[Docket No. FAA-2020-1120; Project Identifier 2019-SW-056-AD]

Airworthiness Directives; Goodrich Externally-Mounted Hoist Assemblies

ACTION: Supplemental notice of proposed rulemaking (SNPRM).

Figure 4 to Paragraph (g)(2)(iv)

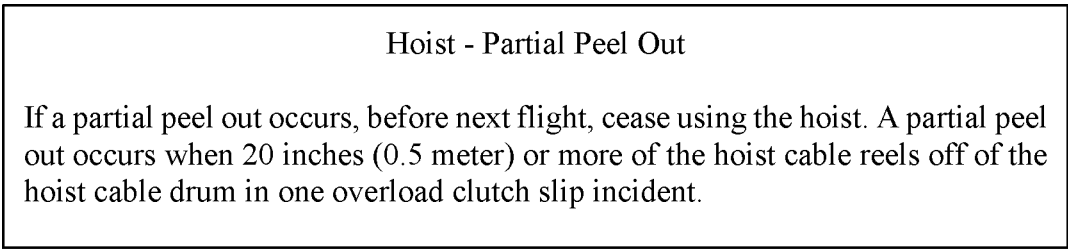
Collins Aerospace stated that although a figure 4 is referenced in the Required Actions of the NPRM, no figure 4 appears in the NPRM.

The FAA agrees. Figure 4 to paragraph (e)(2)(iv) of the NPRM (now Figure 4 to paragraph (g)(2)(iv) of this

SNPRM), which is necessary to accomplish the required actions, was inadvertently omitted in reproduction when the NPRM published in the **Federal Register**.
